System Impact Assessment Report

Lac Des Iles Mine Expansion

CAA ID 2006-226

Applicant: North American Palladium Ltd

FIGURE 1 : CONNECTION ARRANGEMENT

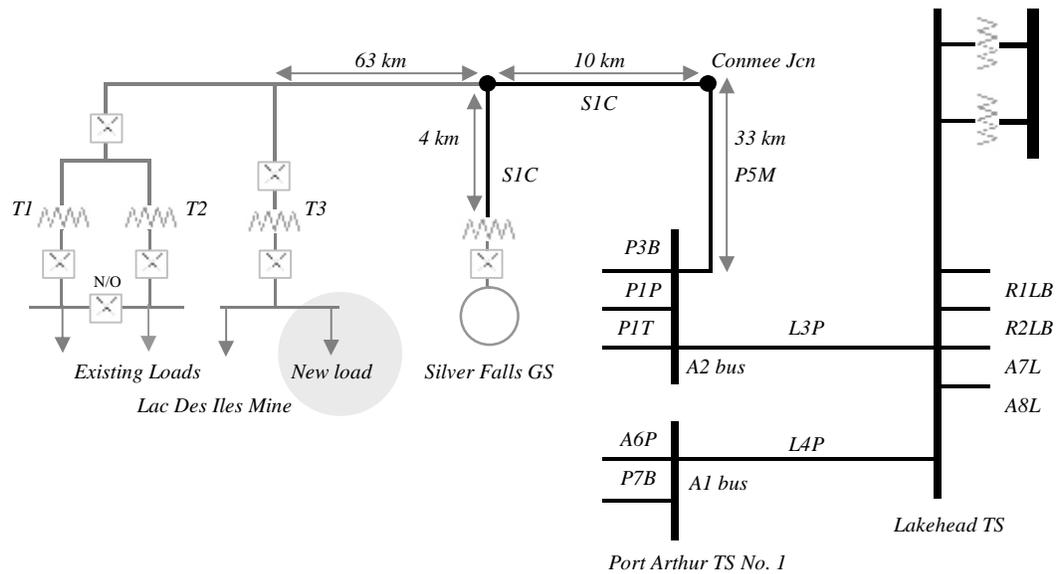
Lac Des Iles mines is presently supplied by a 115 kV circuit that is tapped on to Hydro One owned 115 kV circuit S1C at a point about 4 km from the Ontario Power Generation owned Silver Falls generating station. The S1C is connected to P5M which is about 33 km long and is supplied from Port Arthur TS No. 1. The supply arrangement is shown in Figure 1.

Prior to 2007 summer, the load at Lac Des Iles mines which is supplied by three 120/4.16 kV transformers T1, T2 and T3 is approximately 32 MW at peak. The proponent notified the IESO that a new load in the range of 5 to 10 MW will be added to the transformer T3 to serve the increase in mining operations.

The ratings of T1 and T2 are 20/26/33 MVA and the rating of T3 is 10/13 MVA.

FIGURE 2A : P5M@P + SILVER FALLS GENERATION

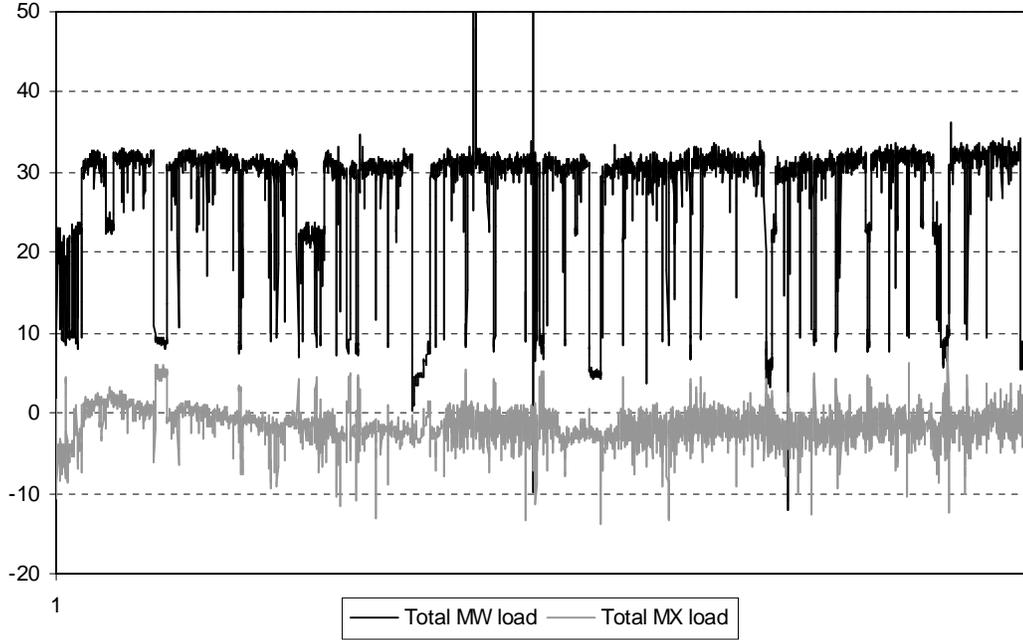
From Figure 2A, it can be concluded that the mine load was approximately 32 MW. This is roughly the same load level the proponent advised IESO as their load. The negative MVar load in the Figure 2A suggests that the mine often injected net reactive power into the connection point on S1C due to existence of their large synchronous motors running with over-excitation.

FIGURE 2B : SILVER FALLS MW AND MVAR GENERATION

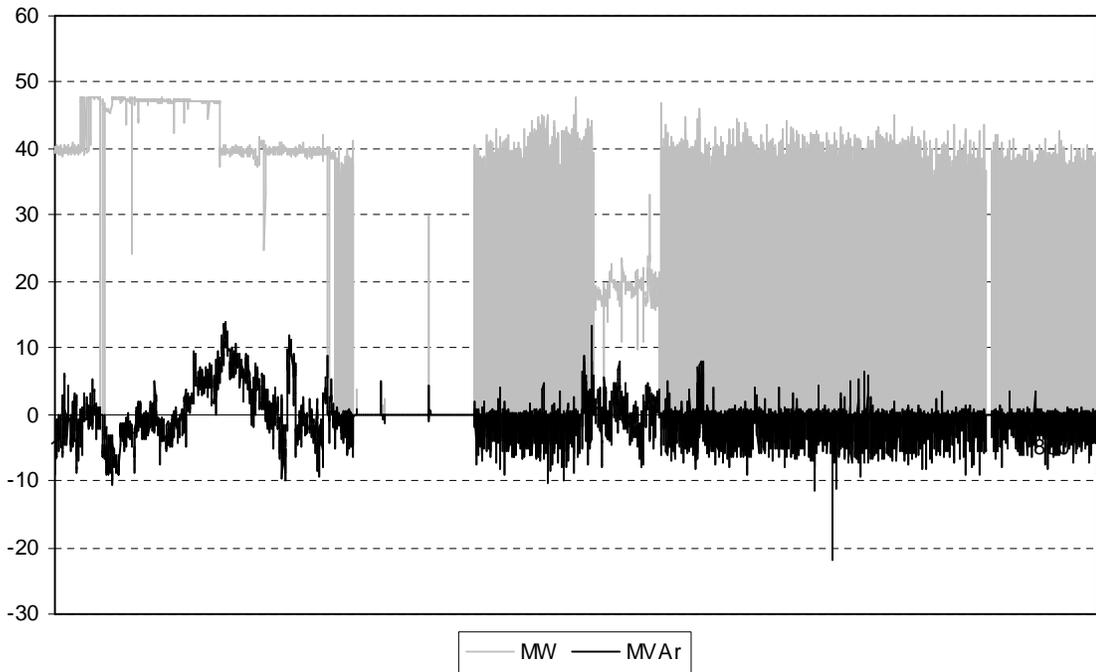
From Figure 2B, it can be concluded that mostly the generation at Silver Falls is about 40 MW, but the peak is approximately 47 MW. Also there could be extended periods of time that this generation is unavailable, and thus can not be a constantly dependant for reactive support for the mine load.

FIGURE 2C : POWER FACTOR CALCULATED FROM P5M@P + SILVER FALLS GENERATION

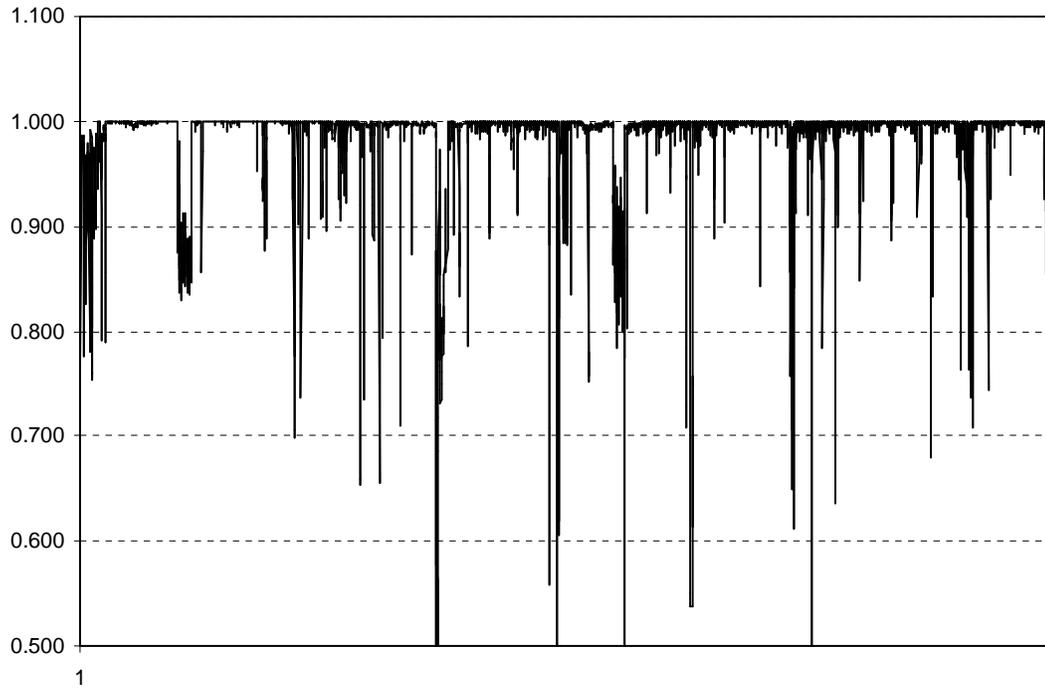
From Figure 2C, it is evident that the power factor at the connection point was mostly unity.

FIGURE 2D : MW (P5M@P + SILVER FALLS GENERATION)

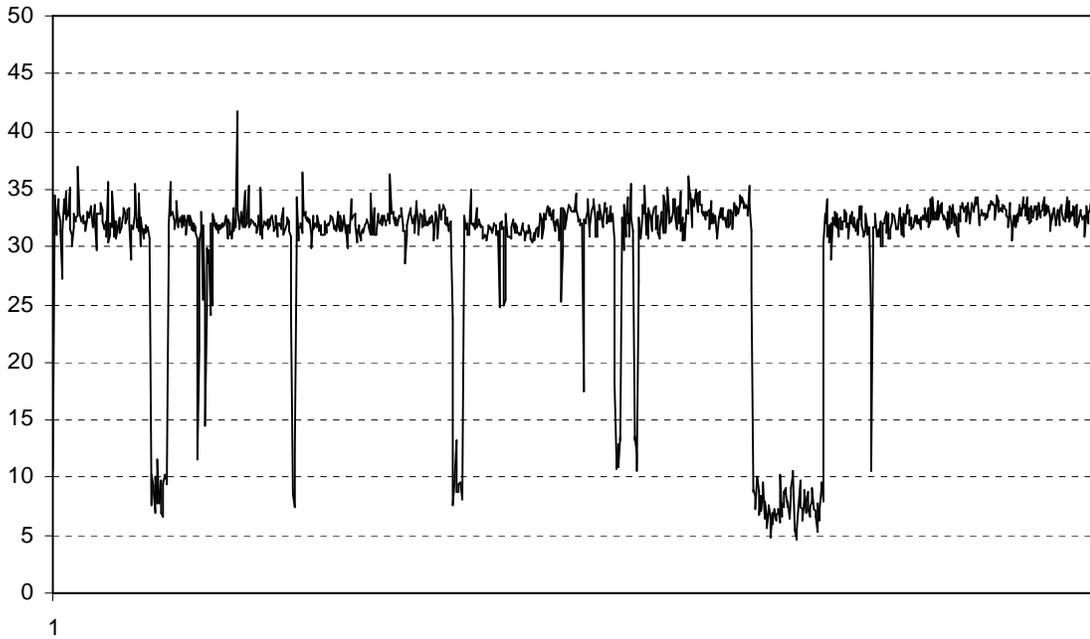
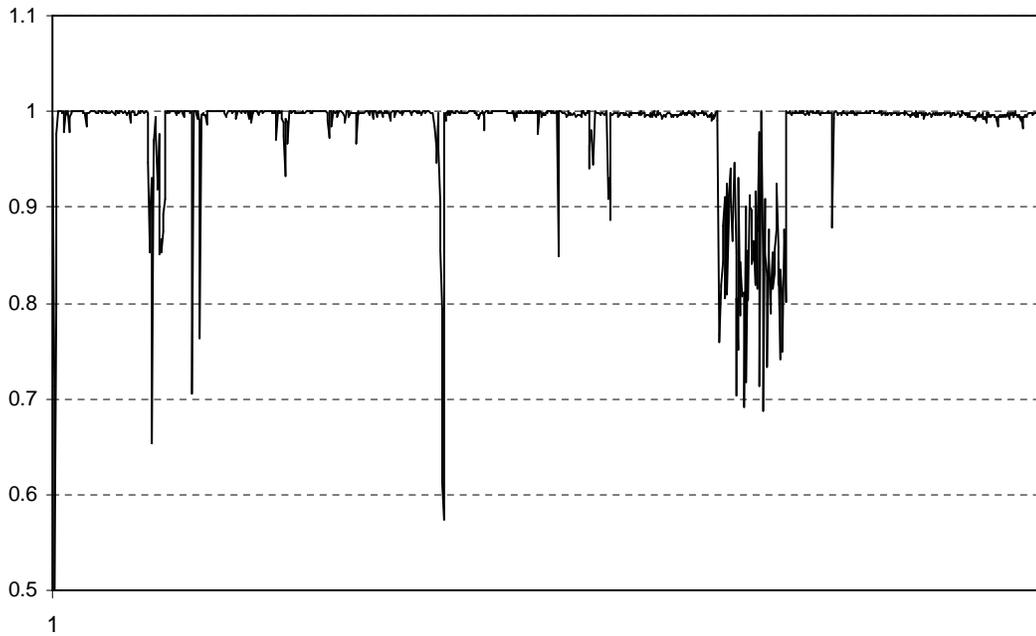
From Figure 2D, it is evident that the mine load is roughly 34 MW. From Figure 2E, it is evident that the power factor at the connection point was mostly unity.
